828-003-14

ADDENDUM NO. 2

**Centenary United Methodist Church
Fire Sprinkler / Fire Alarm Life Safety Improvements**

Centenary United Methodist Church
Fire & Life Safety Improvements
Beatrice, Nebraska
TCEP No.: 828-003-14

M0.01

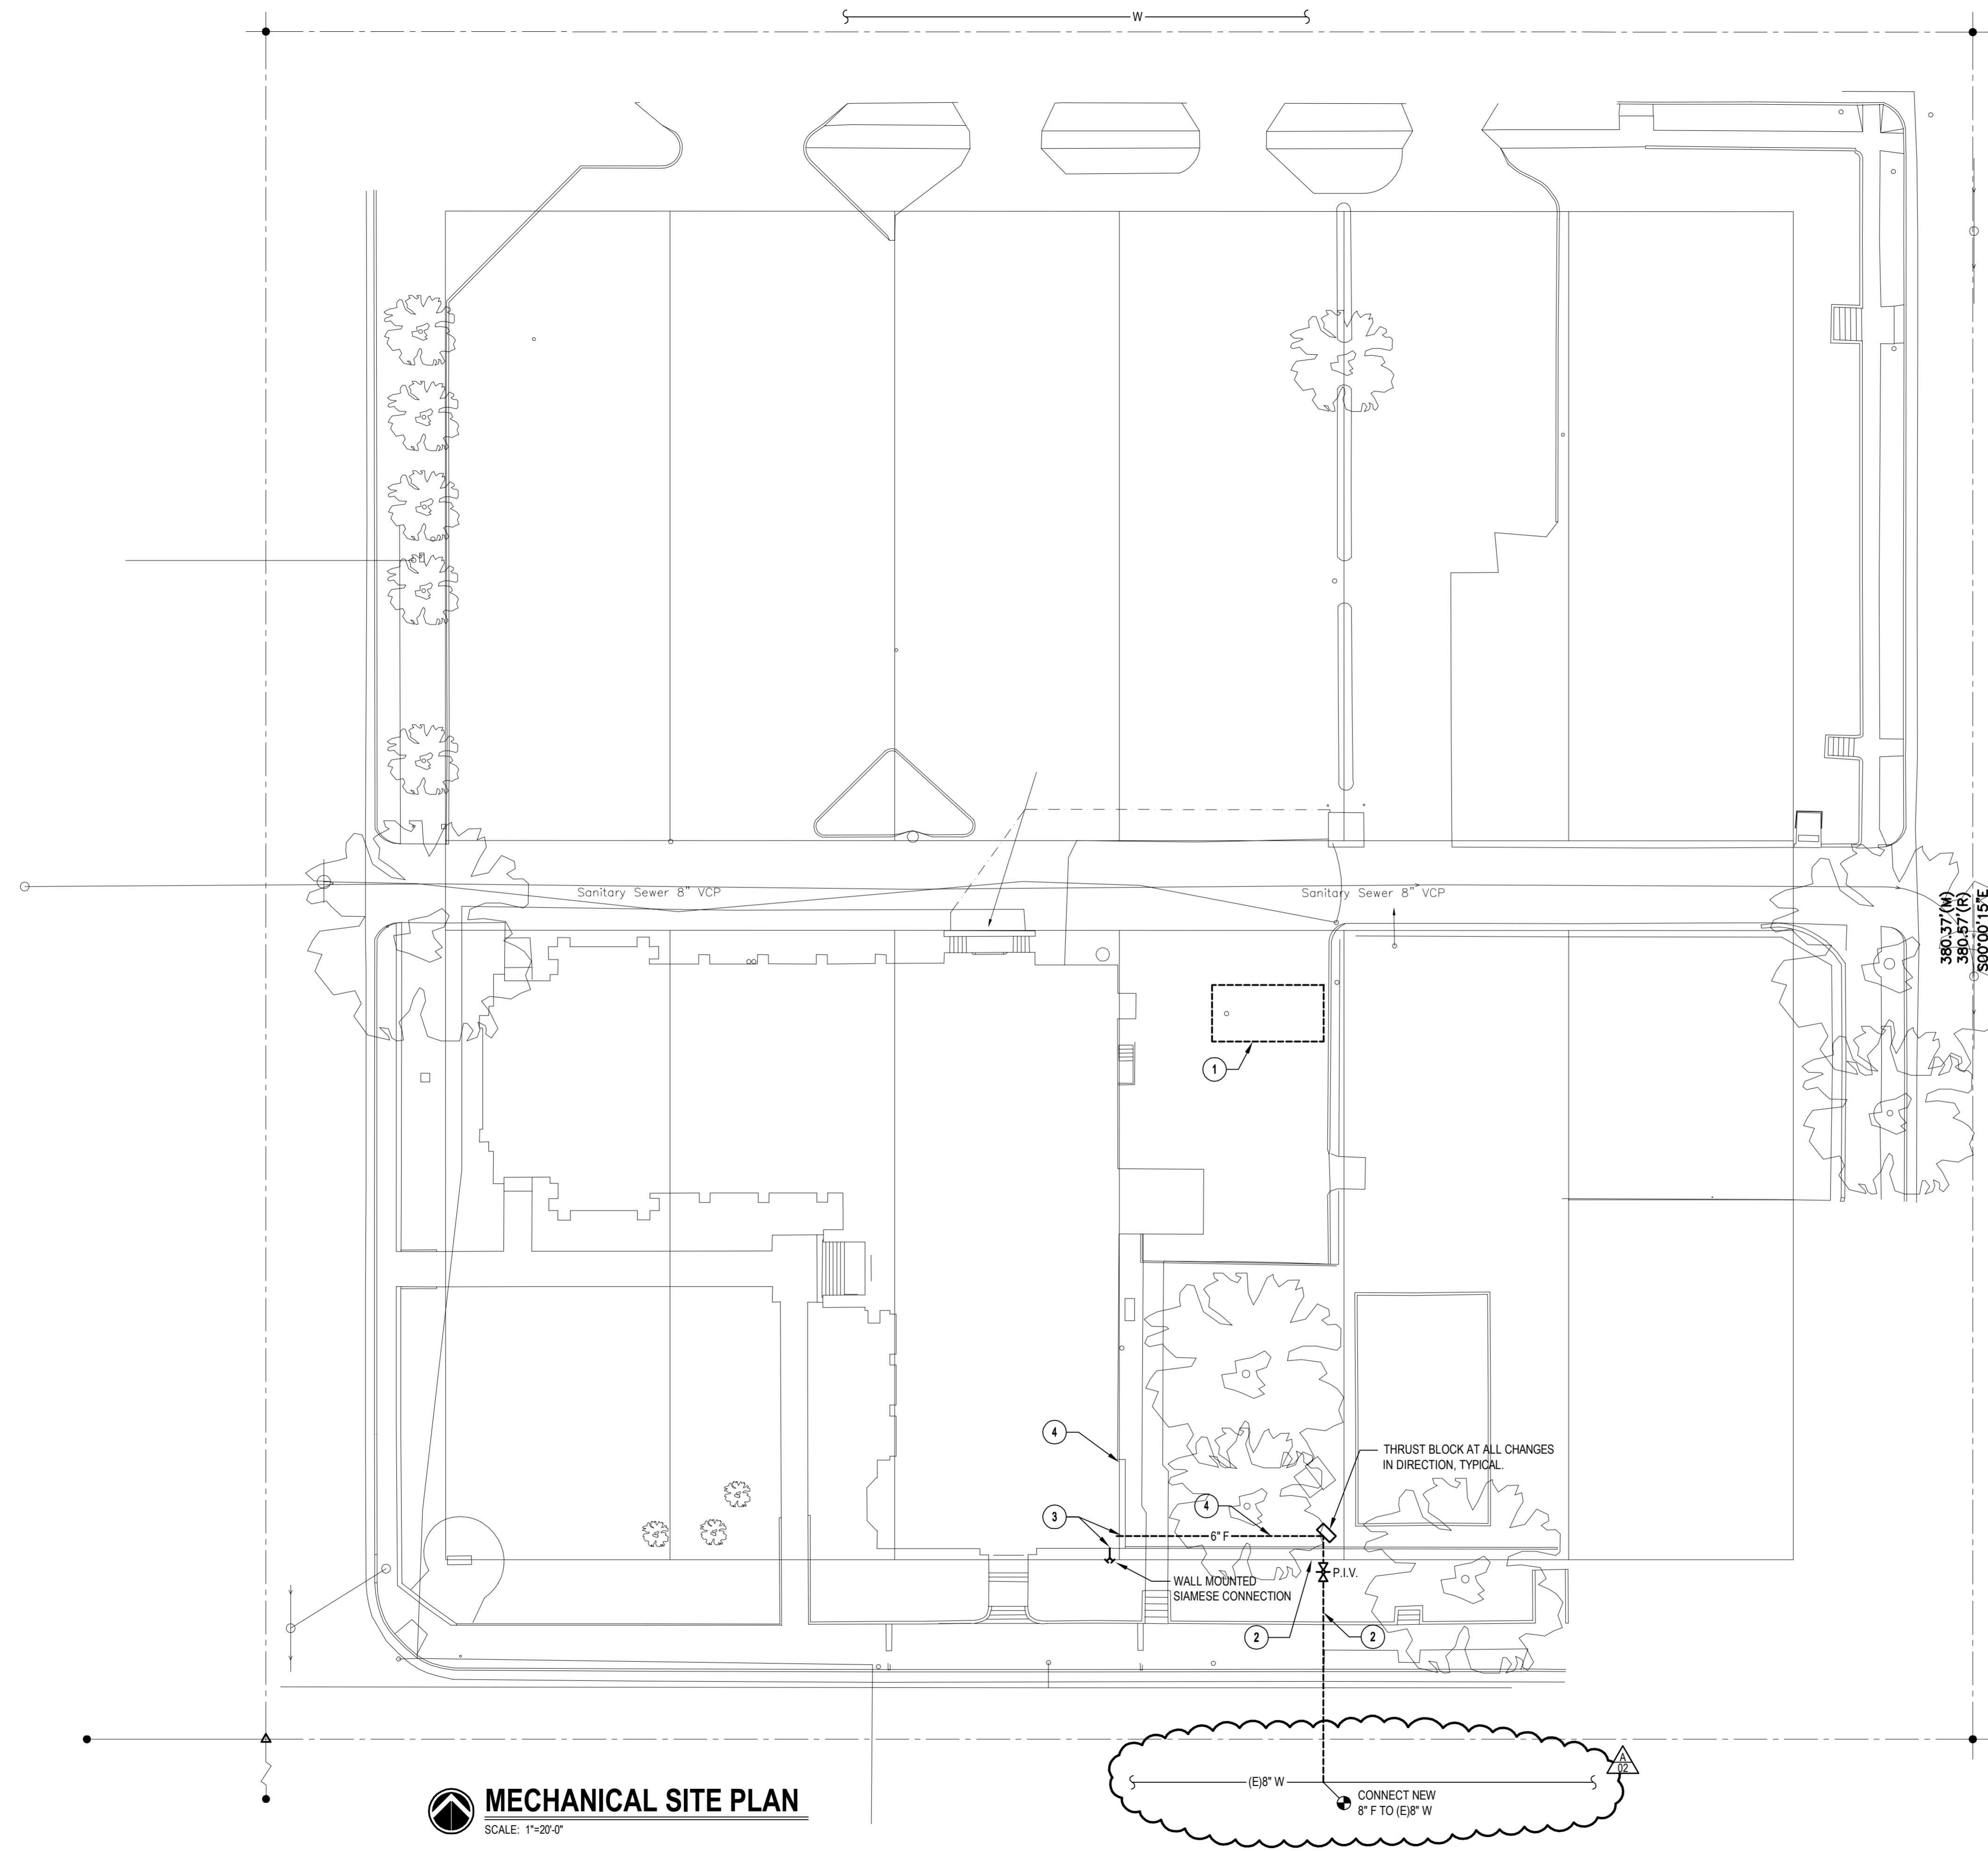
Item 2-11: Sheet M0.01 – Mechanical Site Plan

M0.01 has been re-issued in its entirety to show the fire service tying into the 8" water service main on the south side of Elk Street with a 6" tap.

M1.04

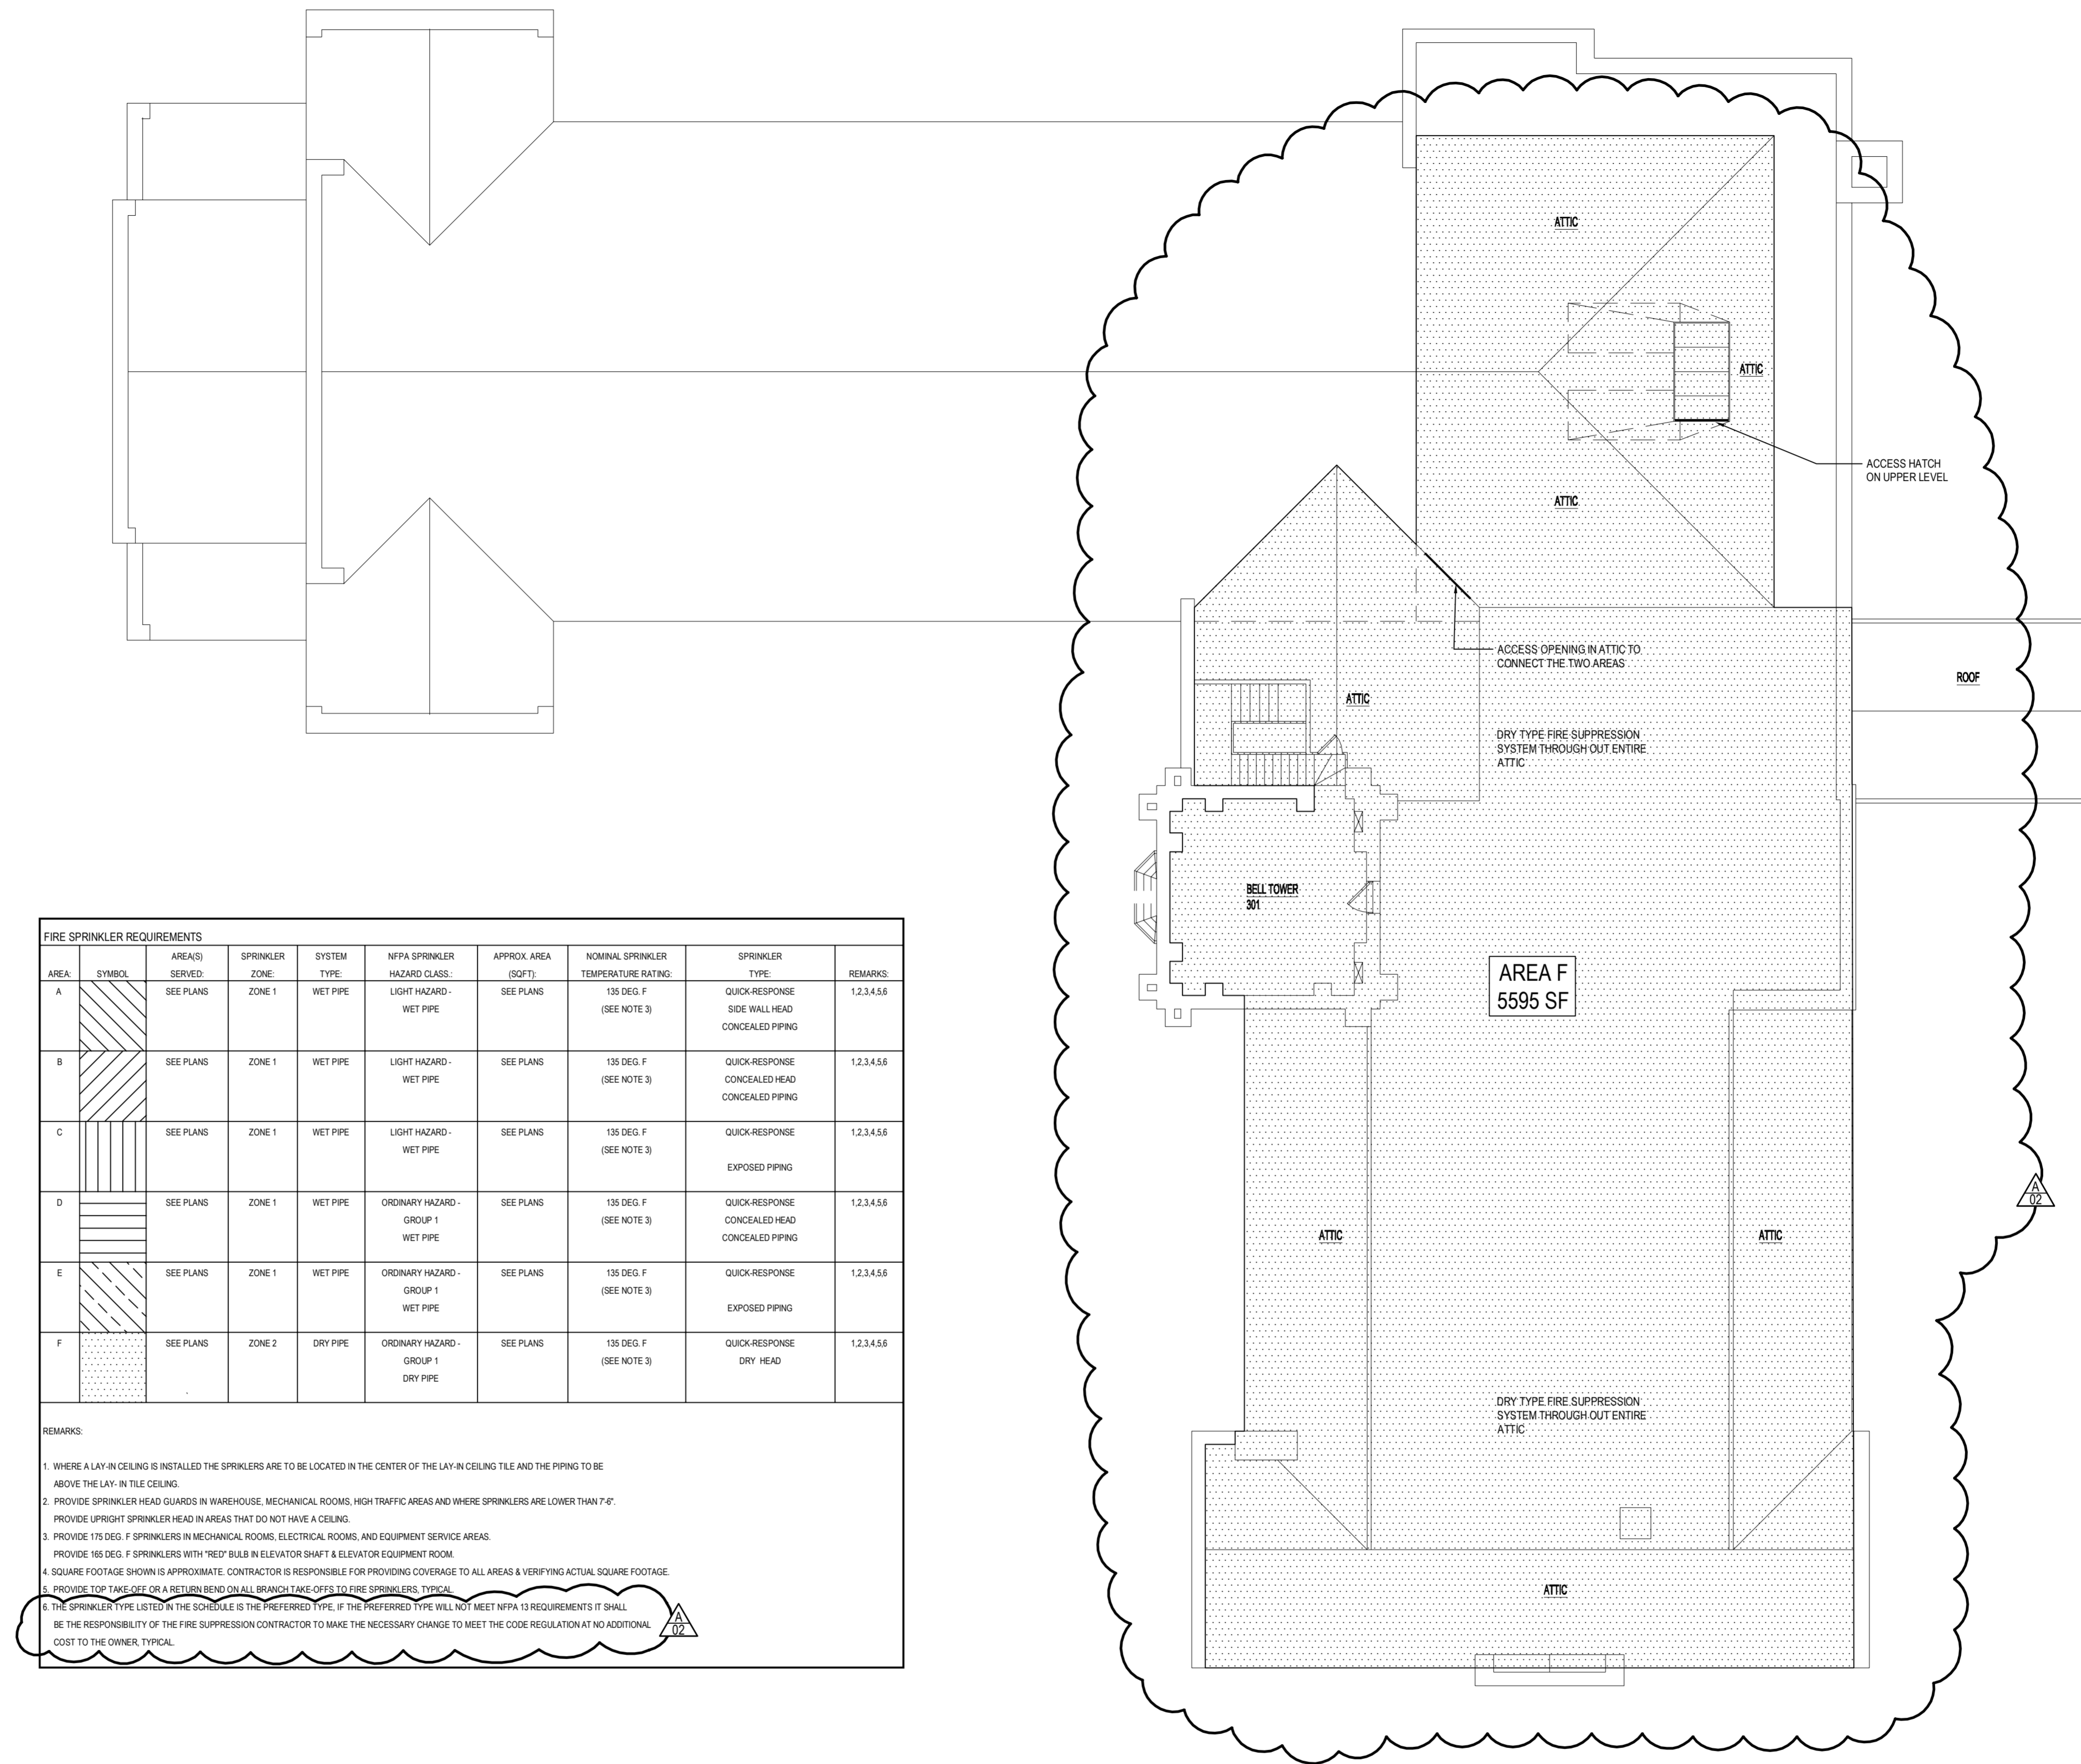
Remark 6. The fire sprinkler type listed in the schedule is the preferred type, if the preferred type will not meet NFPA 13 requirements it shall be the responsibility of the fire suppression contractor to make the necessary change to meet the code regulation at no additional cost to the owner, typical.

Item 2-13: Sheet M1.04 – Bell Tower / Attic Fire Suppression Plan

M1.4 has been re-issued in its entirety to include additional areas to protect with the dry piping system.

- THE SPRINKLER TYPE LISTED IN THE SCHEDULE IS THE PREFERRED TYPE. IF THE PREFERRED TYPE WILL NOT MEET NFPA 13 REQUIREMENTS IT SHALL BE THE RESPONSIBILITY OF THE FIRE SUPPRESSION CONTRACTOR TO MAKE THE NECESSARY CHANGE TO MEET THE CODE REGULATION AT NO ADDITIONAL COST TO THE OWNER, TYPICAL.
